## **LLT AIRPORT SUBDIVISION,** **RESUBDIVISION OF LOT 1**

APPLICATION NUMBER 8 DATE February 5, 2015

REQUEST Subdivision

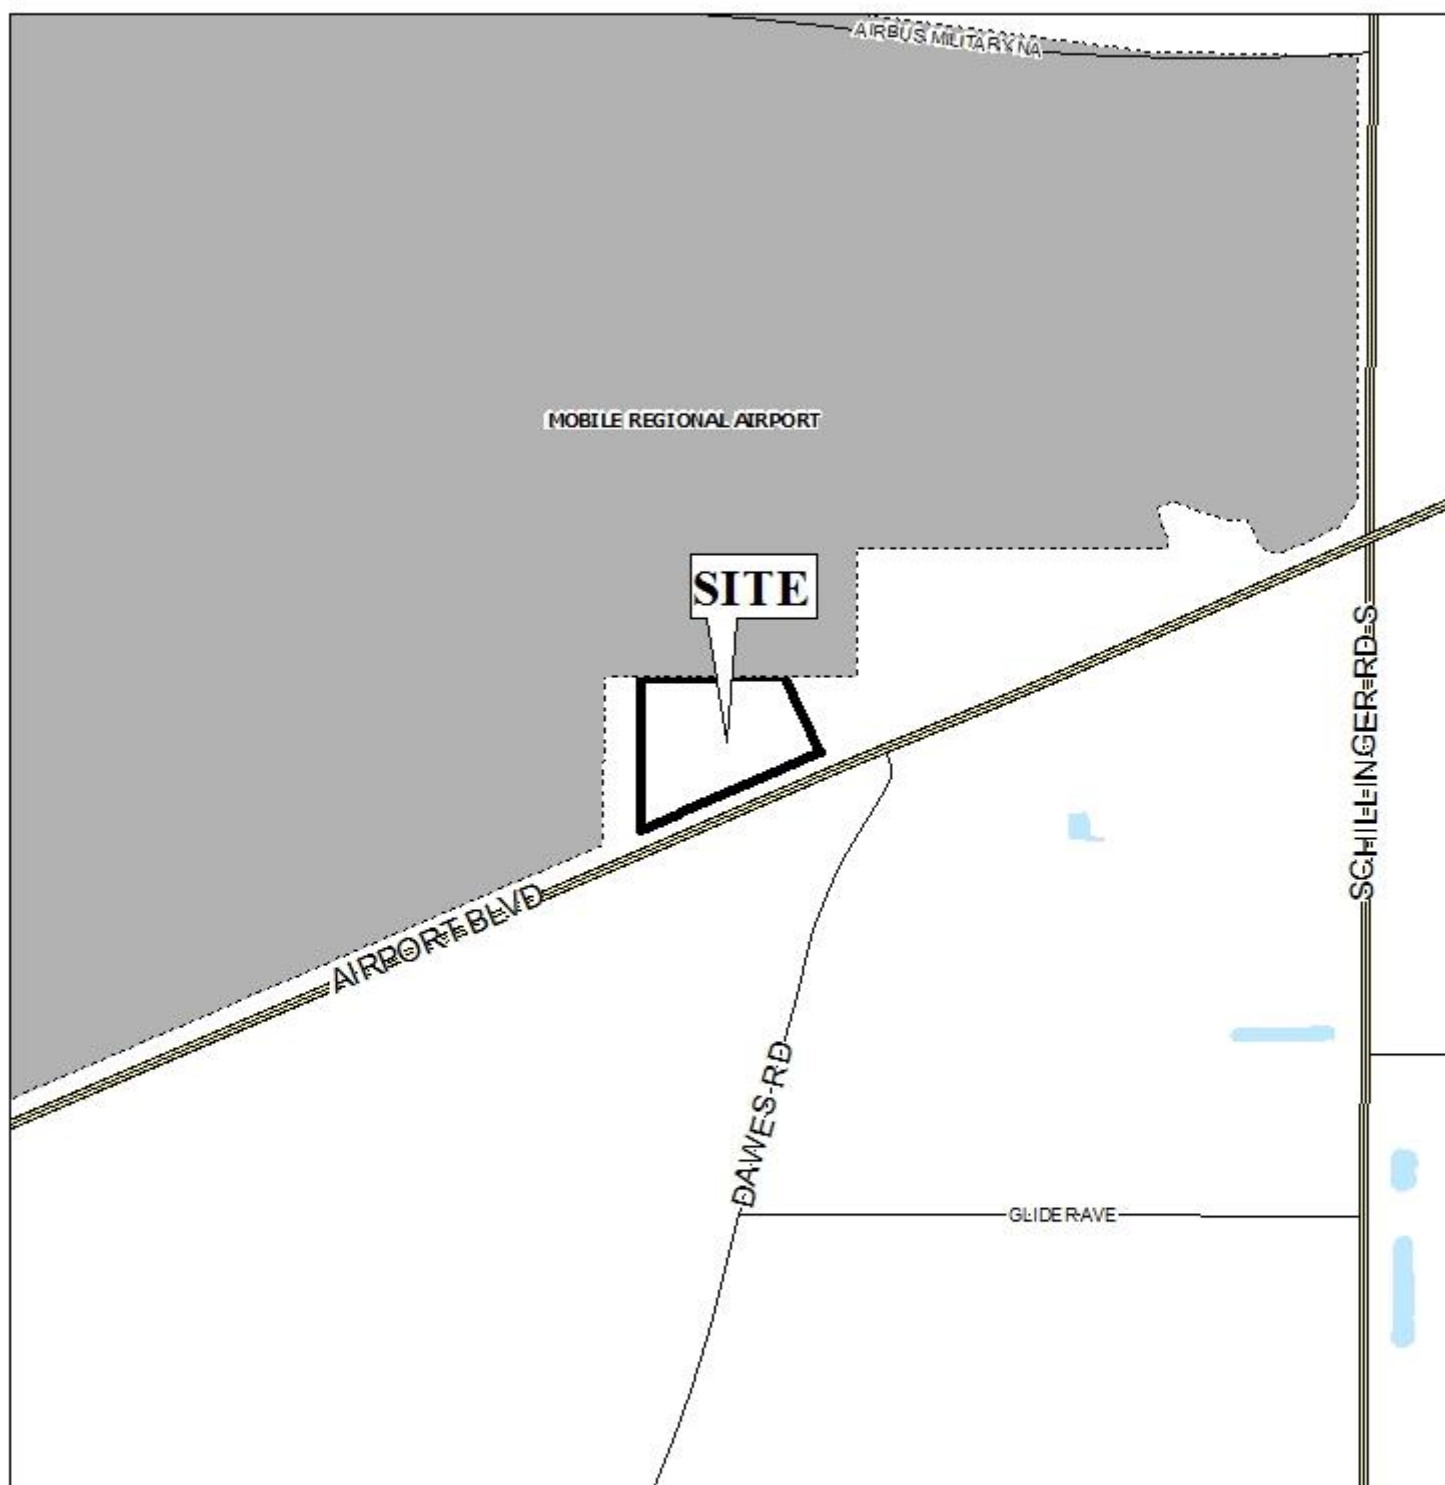
The preliminary plat depicts two (2) easements parallel to Airport Boulevard within the front yard setback of all proposed lots and, if approved, a note should be placed on the Final Plat stating that no permanent structure can be placed or erected within any easement.

It should be pointed out that the proposed Lot B is currently undeveloped. As the 3 proposed lots share access to Airport Boulevard via a 30' non-exclusive reciprocal easement, an approved Administrative PUD will be required for any proposed development of the lot.

- 1) Retention of the 55' minimum building setback line and lot size information on the Final Plat;
- 2) Retention of the right-of-way width of Airport Boulevard on the Final Plat;
- 3) Retention of all easements on the Final Plat and placement of a note on the Final Plat stating that no permanent structure(s) can be placed or erected within any easement;
- 4) Placement of a note on the Final Plat stating that the site is limited to the existing curb-cuts, with any changes to the size, design and location to be approved by Traffic Engineering;
- 5) Development of Lot B will require an approved Administrative PUD for shared access;
